FirstEnergy Nuclear Operating Company

October 31, 2001  
L-01-135

**Subject: Beaver Valley Power Station, Unit No. 1 and No. 2**  
**BV-1 Docket No. 50-334, License No. DPR-66**  
**BV-2 Docket No. 50-412, License No. NPF-73**  
**License Amendment Request Nos. 295 and 167**

Beaver Valley Power Station, Unit No. 1  
License Amendment Request No. 295

FIGURE 3.4-2

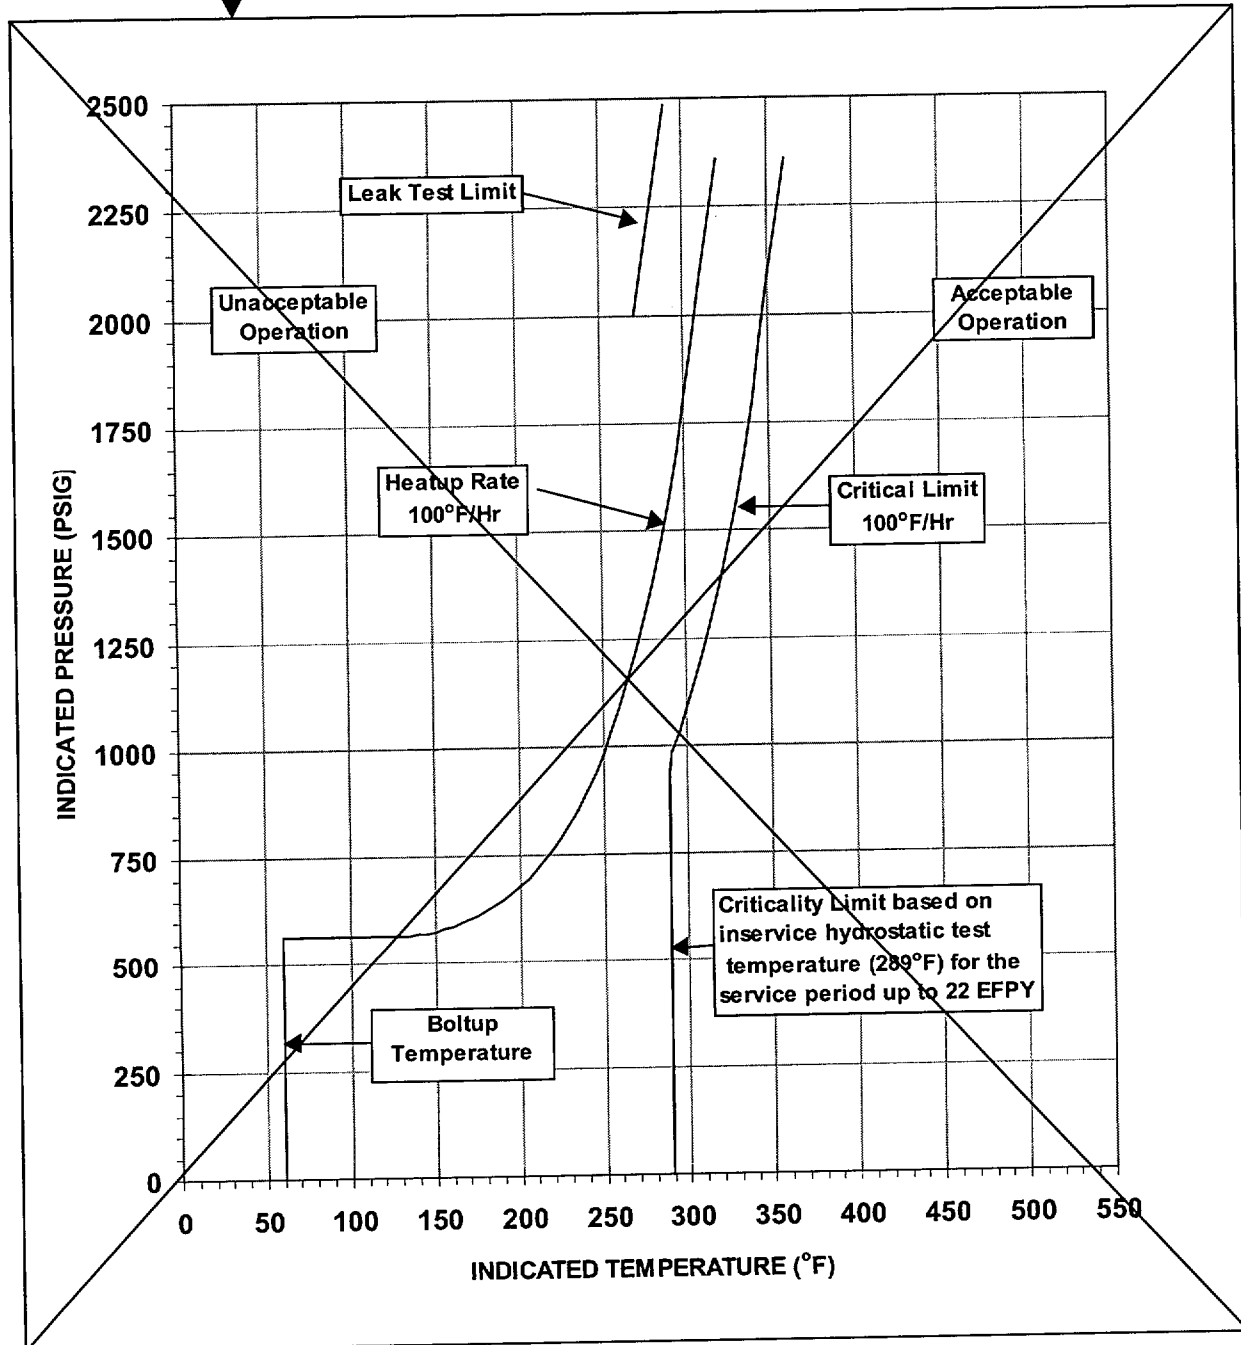
Moved to PTLR.

6. Relocate Table B 3/4.4-1 to the PTLR for both units.
7. Relocate Figure B 3/4.4-2 to the PTLR for both units.
8. Revise Figure Index to show the deletion of Figures 3.4-2, 3.4-3, B 3/4.4-1 and B 3/4.4-2 for Unit 1 only.

FIGURE 3.4-3  
Beaver Valley Unit 1 Reactor Coolant System Cooldown  
Limitations Applicable for the First 22 EFY

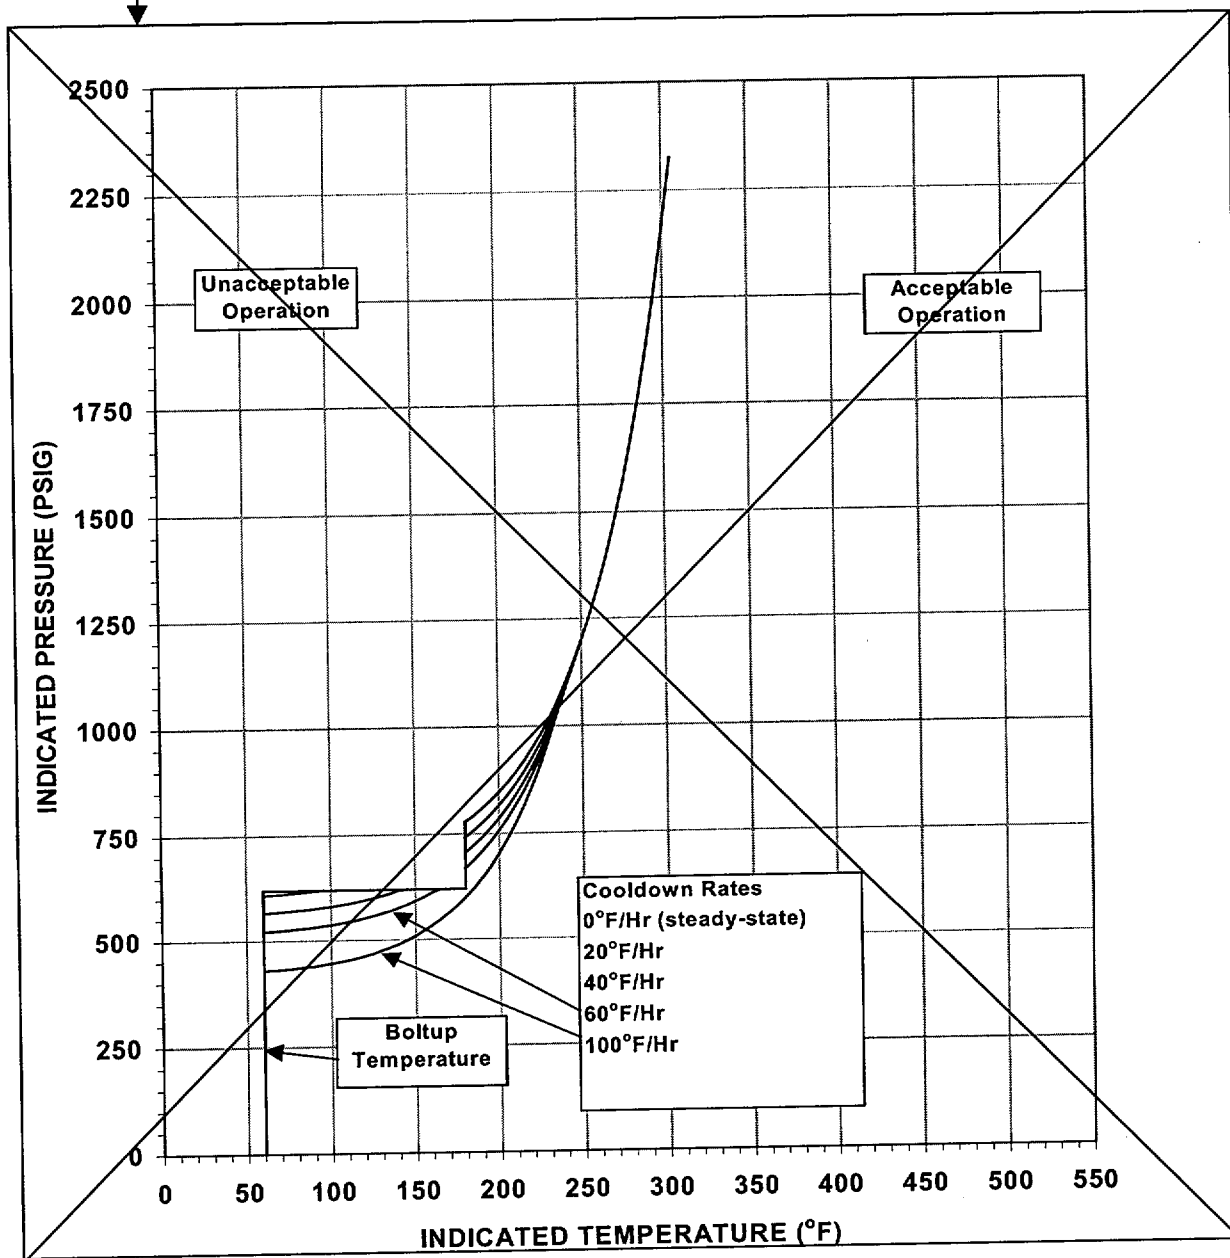
Moved to PTLR.

**FIGURE 3.4-2**

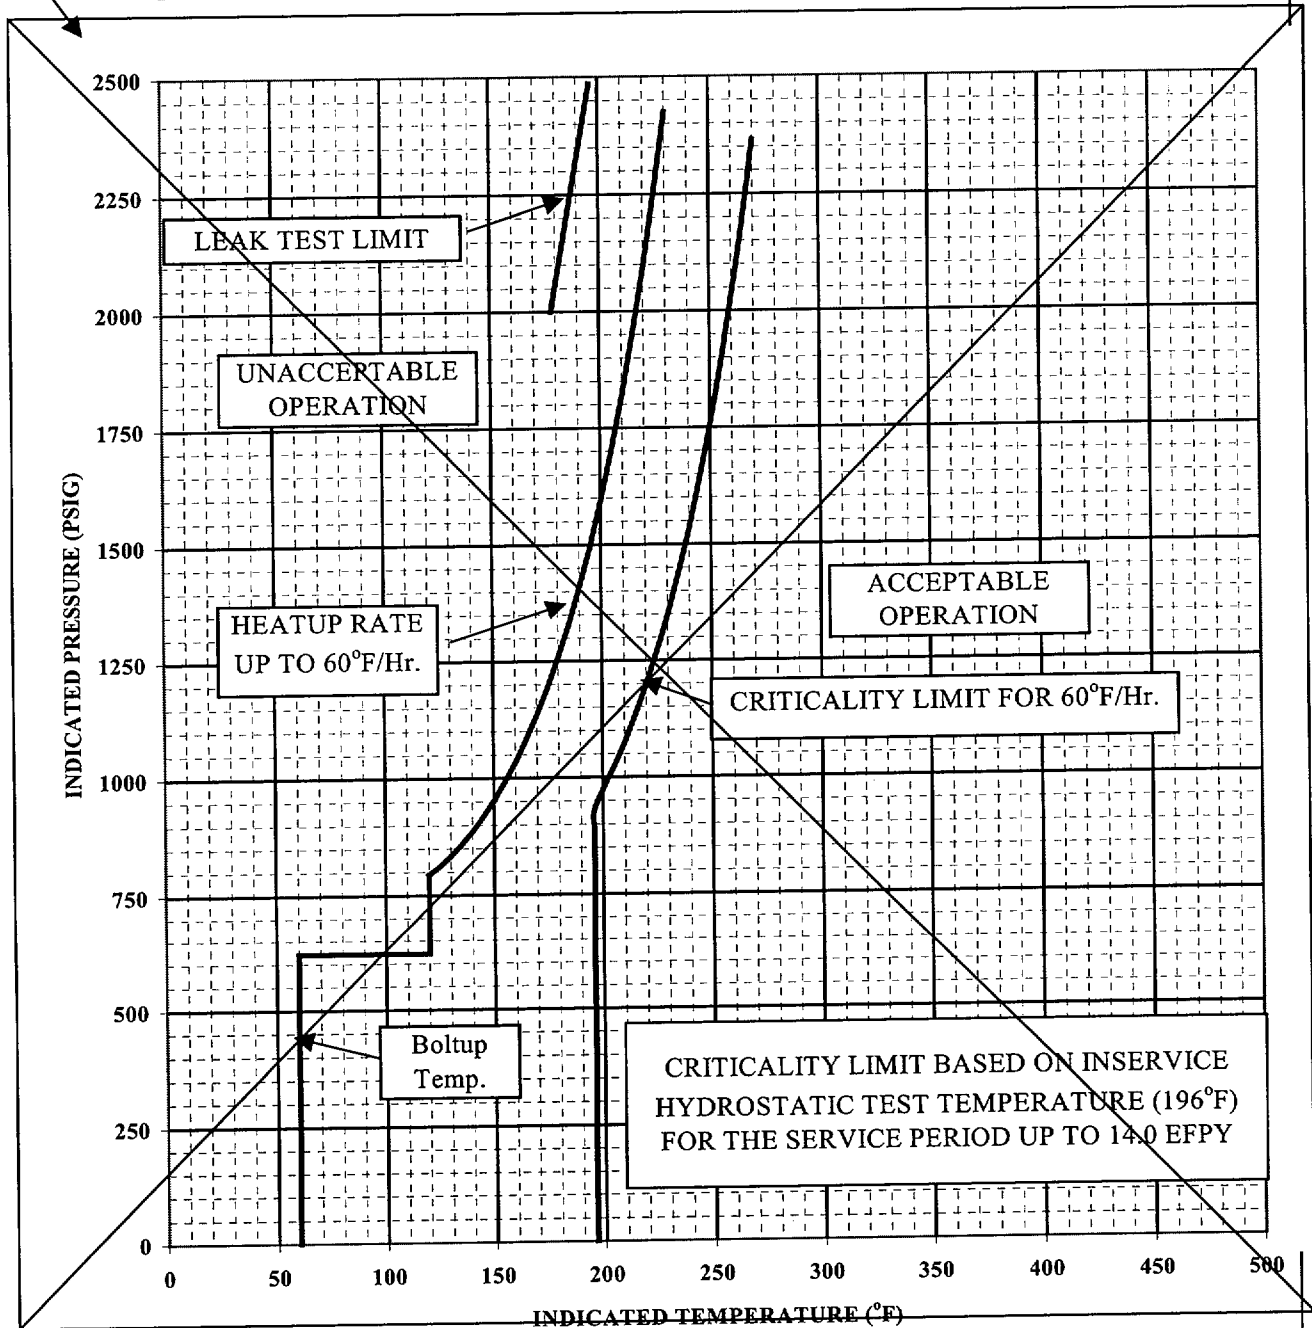
Moved  
to  
PTLR.

FIGURE 3.4-3 (Sheet 1 of 5)  
Beaver Valley Unit 2 Reactor Coolant System Cooldown  
Limitations Applicable for the First 14 EFPY  
BEAVER VALLEY — UNIT 2 3/4 4-32 Amendment No.122  
(Proposed Wording)

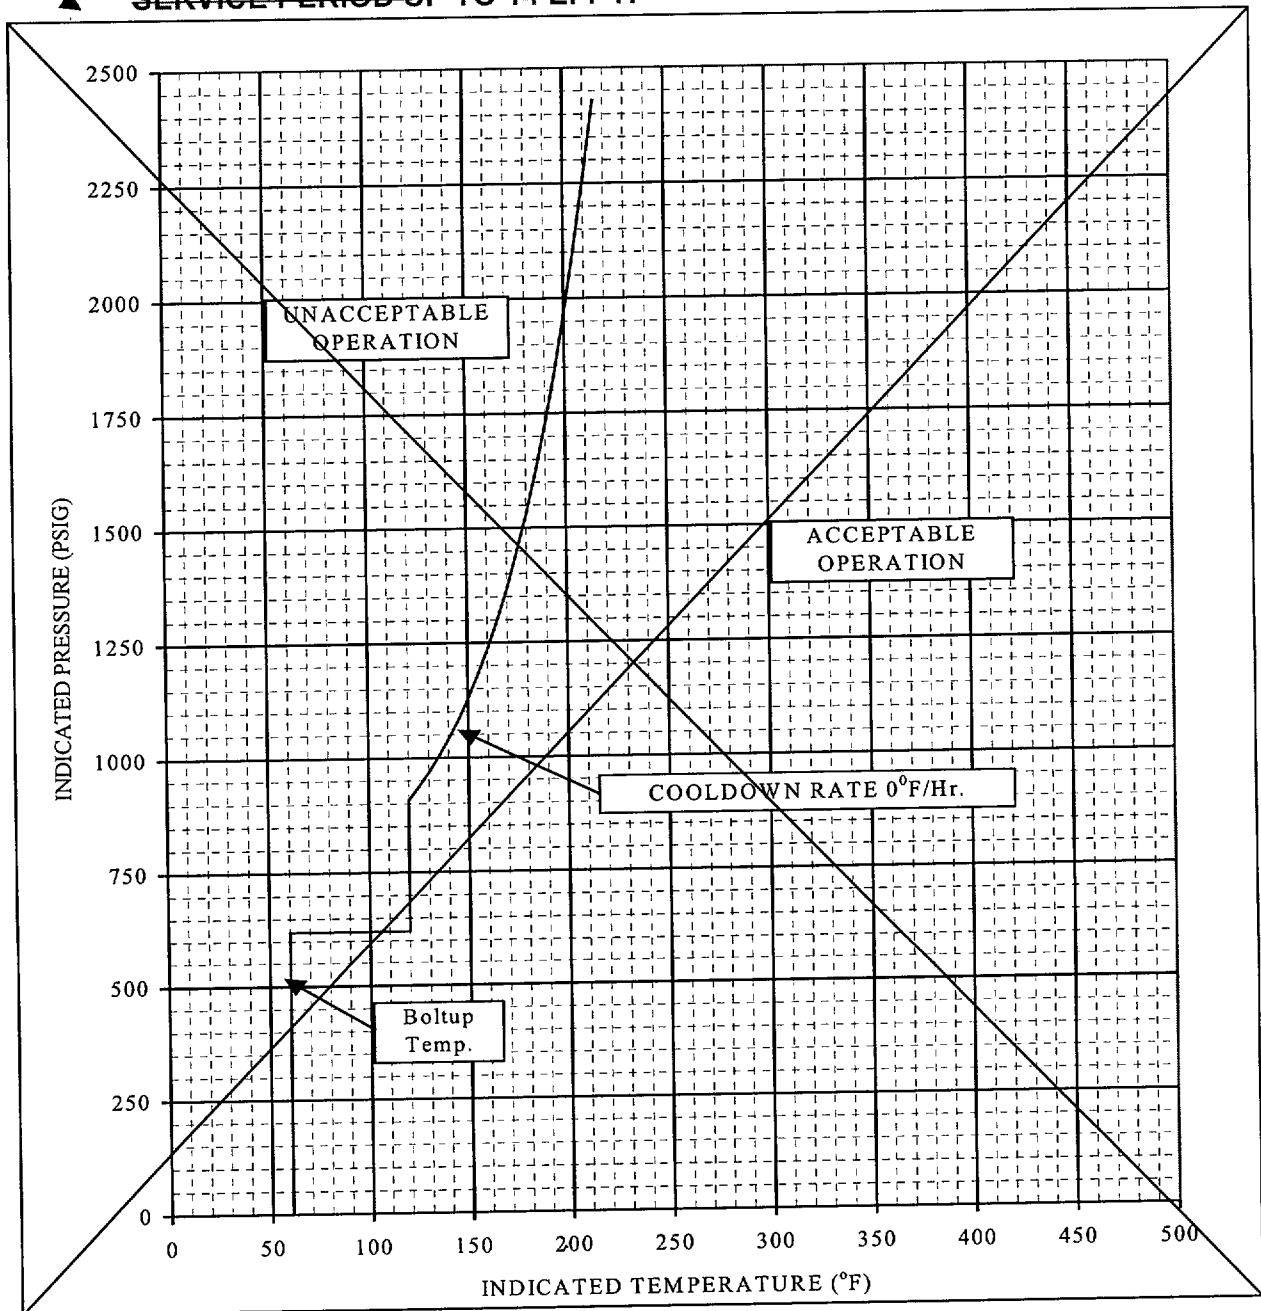
Moved  
to  
PTLR.

FIGURE 3.4-4

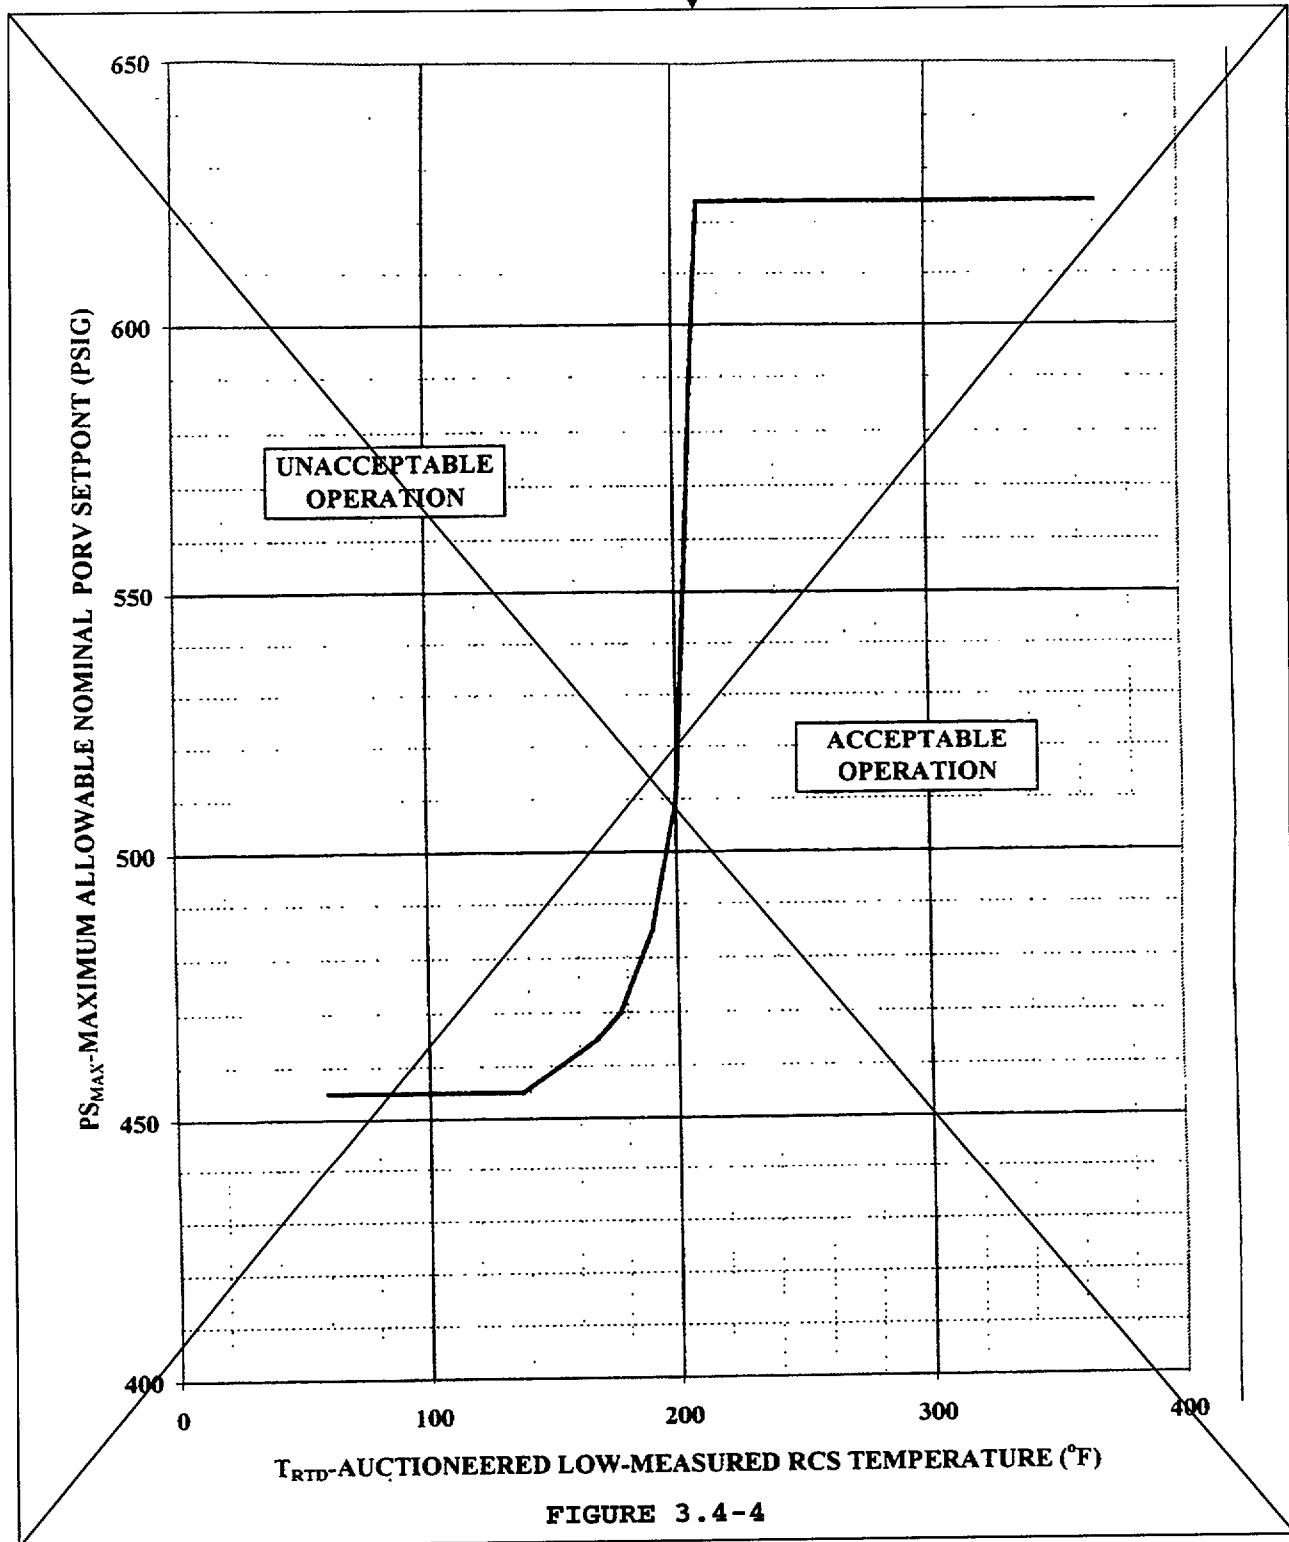
Moved to PTLR.

9. Relocate Figure 3.4-4 to the PTLR for Unit 2 only.
10. For Unit 2 only, revise 375°F referenced in the following Technical Specifications to "the enable temperature specified in the PTLR plus 25°F".

FIGURE B 3/4 4-2

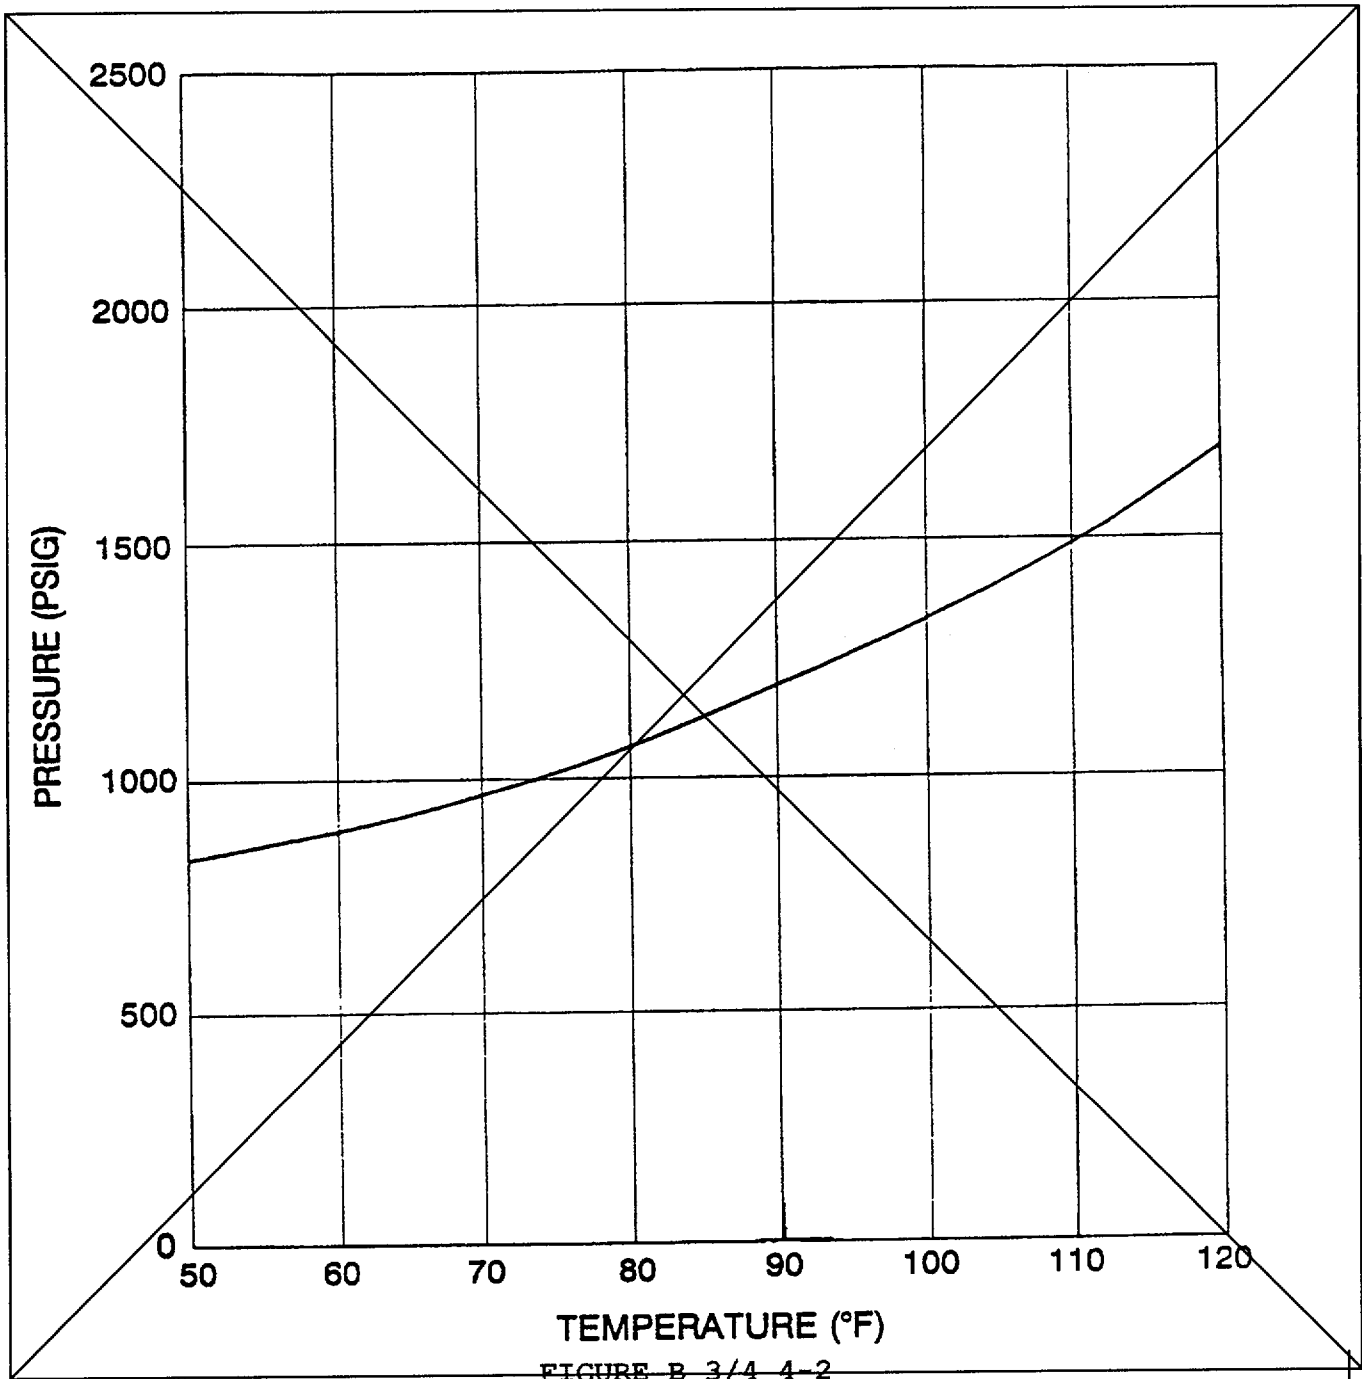
Moved to PTLR.
